The Port is seeking non-material variations to the project’s Marine Construction Licence in accordance with section 30(7) of the Marine Scotland Act 2010. This document sets out the details of the requested variations and explanation of their non-material nature.

Document ID 400.DWT/Docs/SPA/Marine Licensing	Date Revised 27-08-24	Review date N/A	Page No. Page 1 of 9
---	---------------------------------	---------------------------	--------------------------------

DEEP WATER TERMINAL PROJECT**REQUEST FOR NON MATERIAL VARIATION TO MARINE CONSTRUCTION LICENCE****APPENDIX 1****INDICATIVE DETAILS OF FLOATING LINKSPAN**

Figure 1: Section through indicative floating linkspan

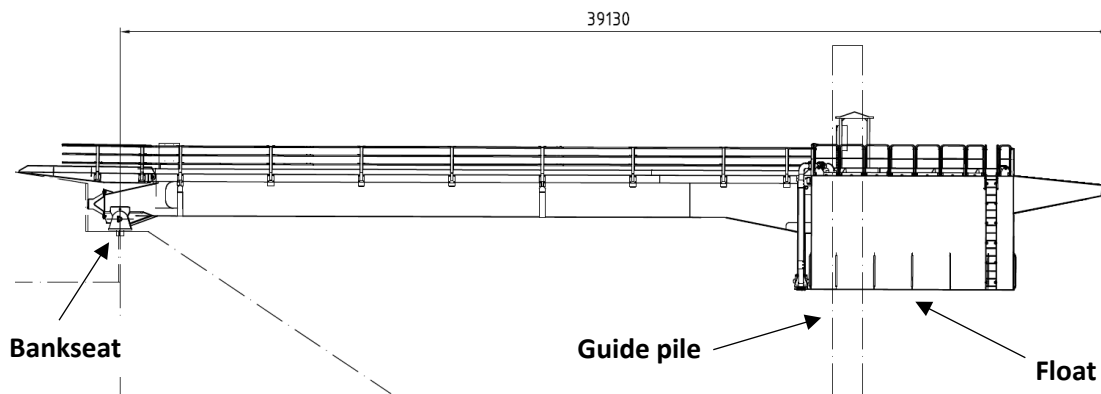
Following contract award, the opportunity to change from a hydraulic to a floating linkspan was identified. Following a thorough examination, the Port identified that a floating linkspan would provide the best value in the long term.

A floating linkspan is connected to the bankseat by means of a hinged connection which allows the ramp to rise and fall with the tide. The weight of the linkspan and the vehicles that use it are supported by a submerged float. The linkspan ramp is secured by means of a guide pile. Figure 1 below shows an indicative section through a floating linkspan. An indicative drawing is provided in Appendix 1. This option therefore means that the linkspan automatically corrects for the tides without the need for major power to control the lifting and lowering mechanisms. The operation of the floating linkspan therefore requires less electrical power than a hydraulic one, thereby reducing carbon emissions. Additionally, there is less risk of pollution as there is no hydraulic fluid in the operating system.

Figure 2: Plan showing consented dolphins for linkspan

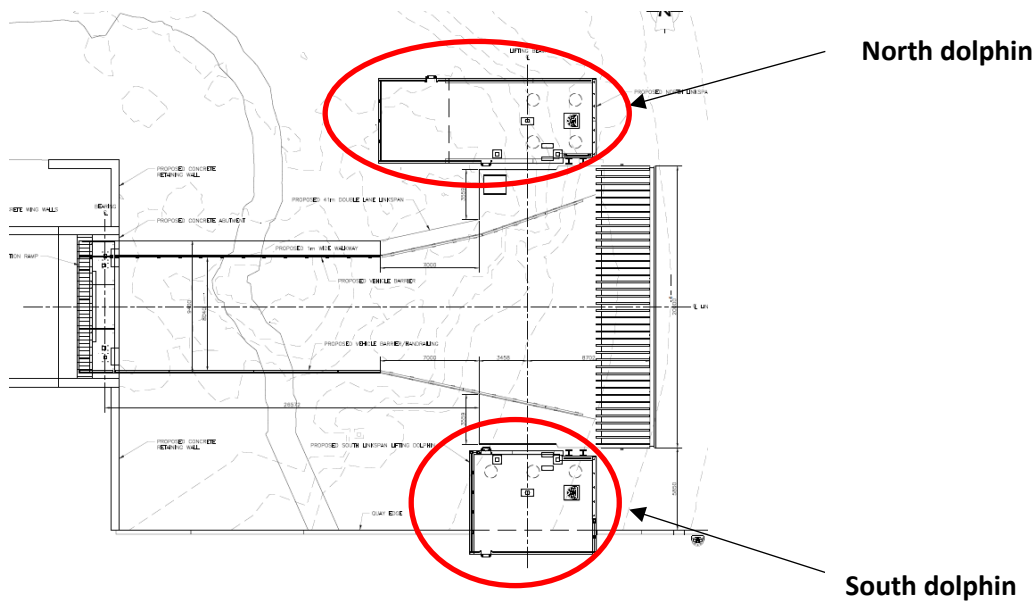
Figure 2 below shows the plan of the consented design, including the two concrete dolphins. Drawings are provided in Appendix 2.

As a result of this design change, the dolphins that would have been required for the hydraulic linkspan are no longer required, reducing the amount of piling, and concrete required; thereby reducing the interaction with the seabed. Details of the omission are given in Section 4 below.

DRAWING TITLE
LINKSPAN GENERAL LAYOUT

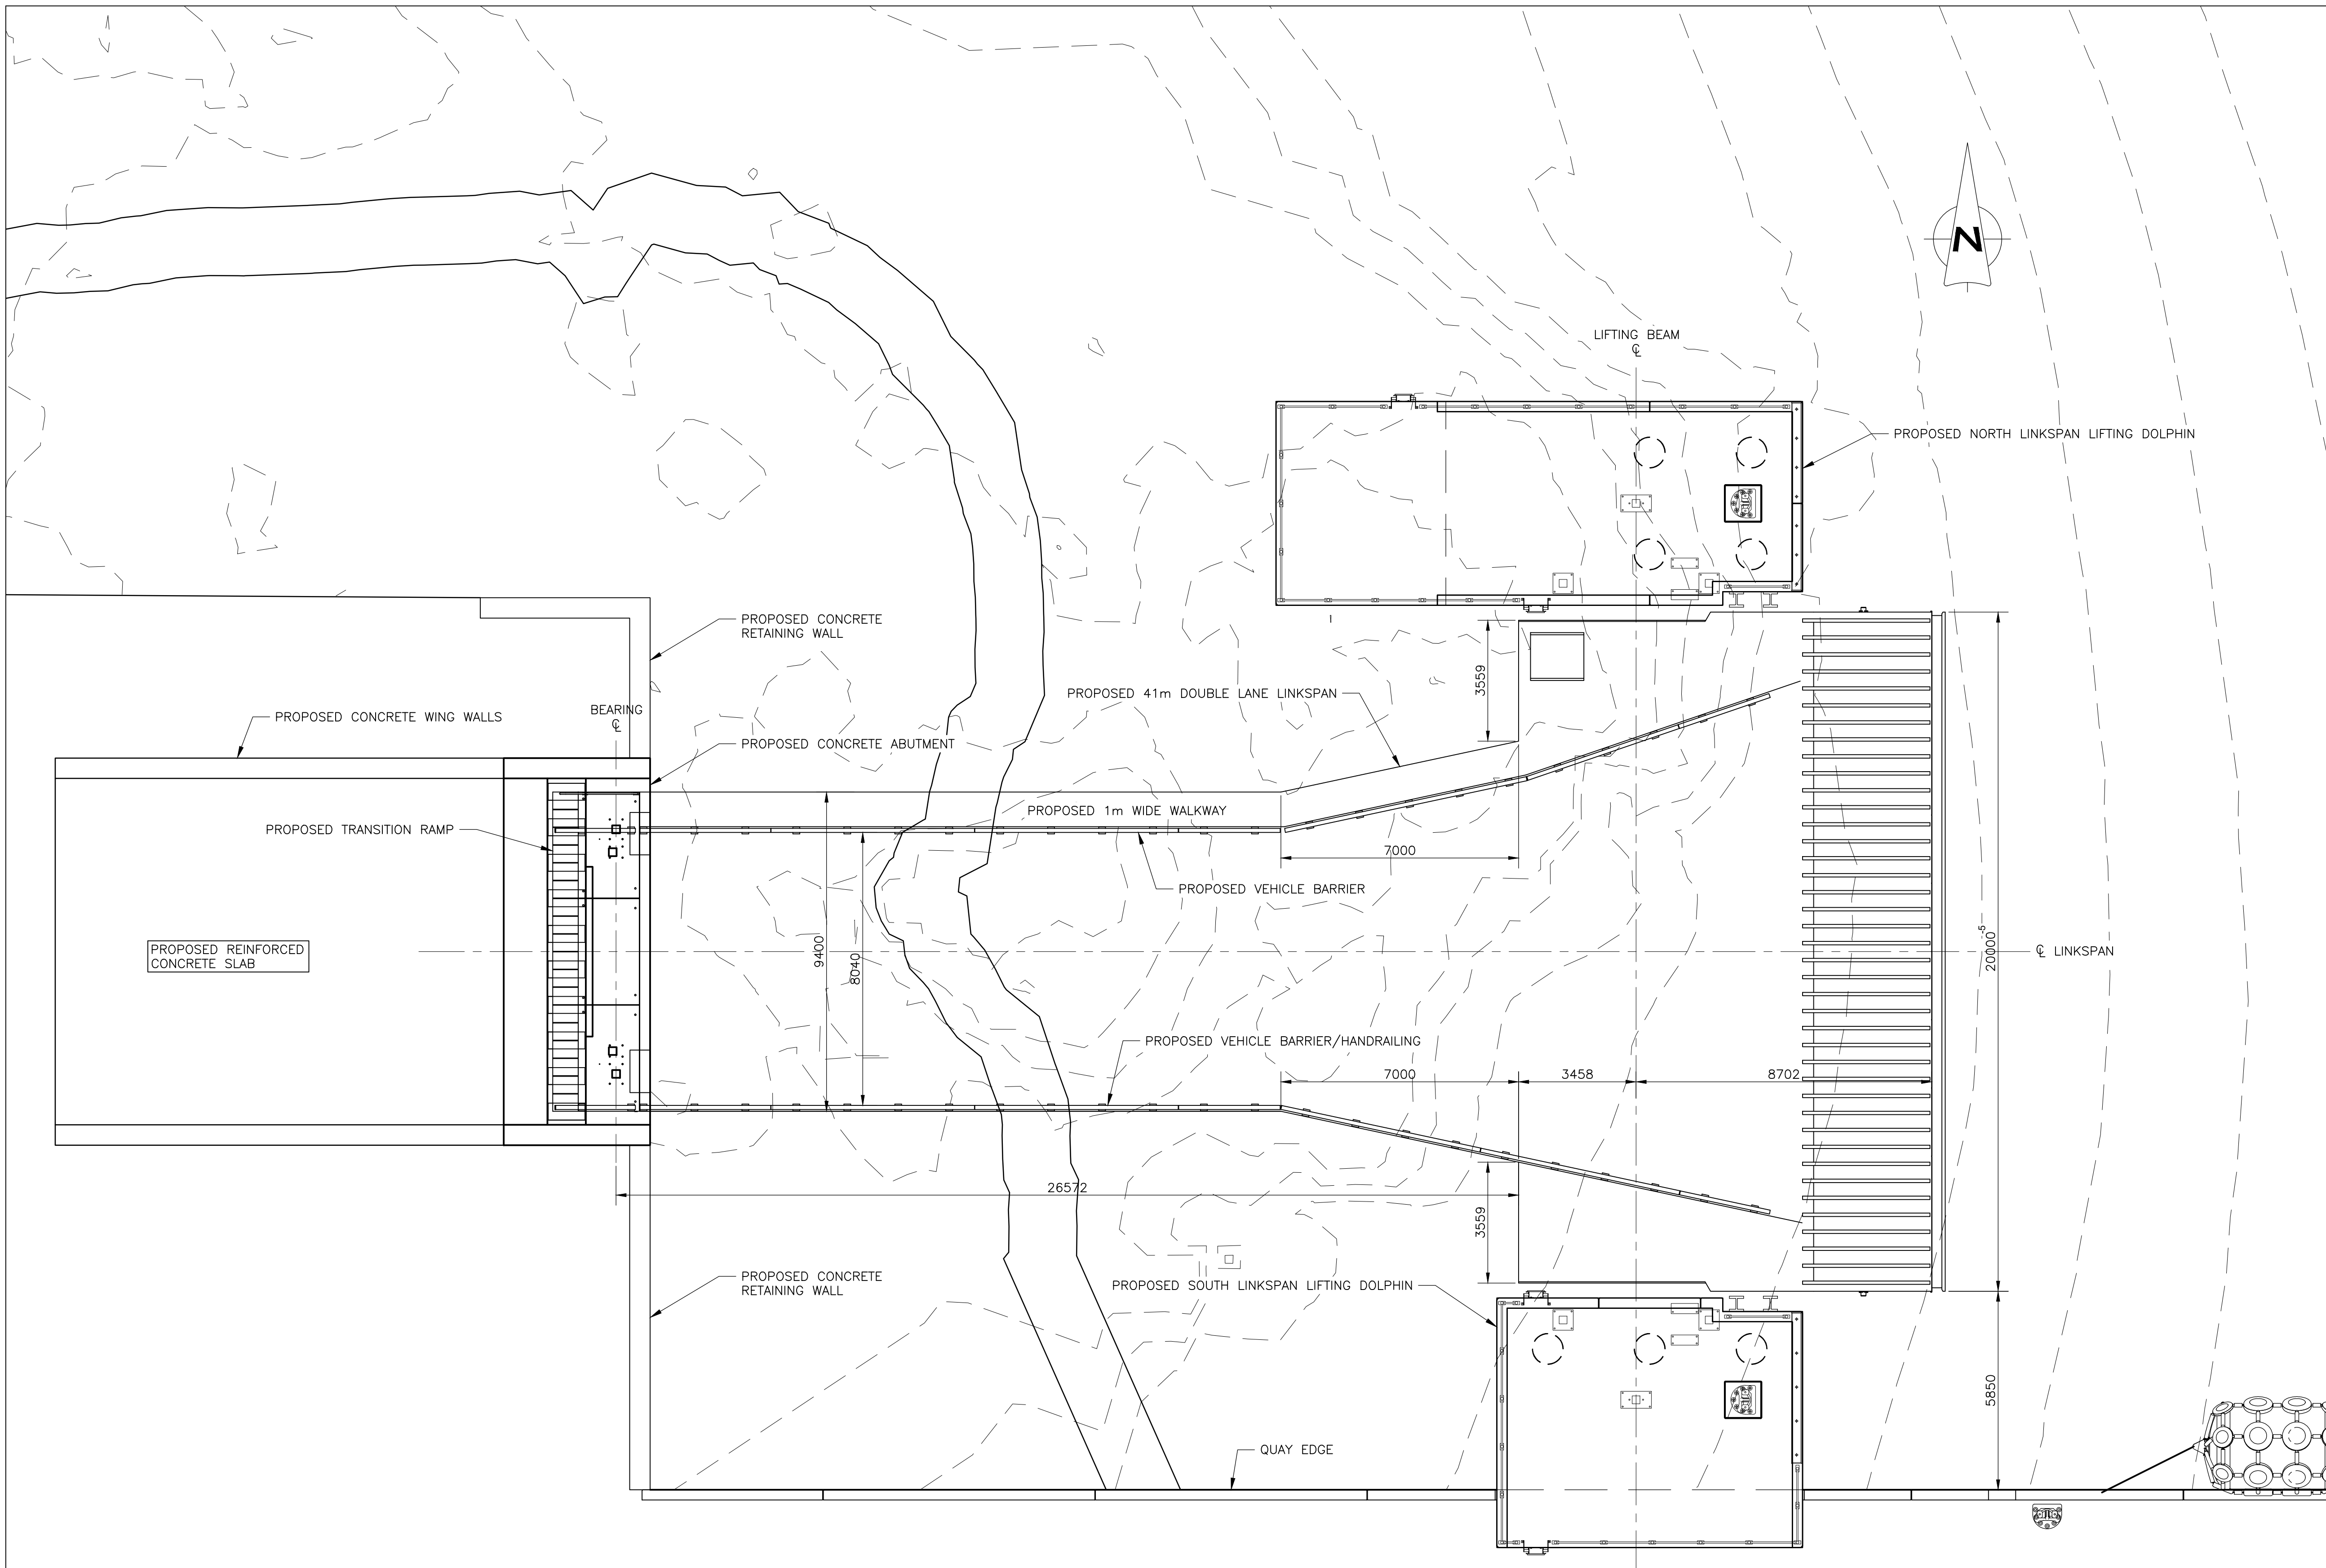
Ref	Item	Description	Materials omitted from works	Comment
1	Linkspan dolphins	2 No. reinforced concrete blocks cast on the seabed supported by steel piles. North dolphin: 15m x 8m in area, supported on 4 No. piles South dolphin: 9m x 7m in area, supported on 3 No. piles. The piles were to be driven to rock by vibrating hammer and	Concrete Steel reinforcement 7 No. 800mm diameter steel piles	Copies of drawings included in Appendix 2
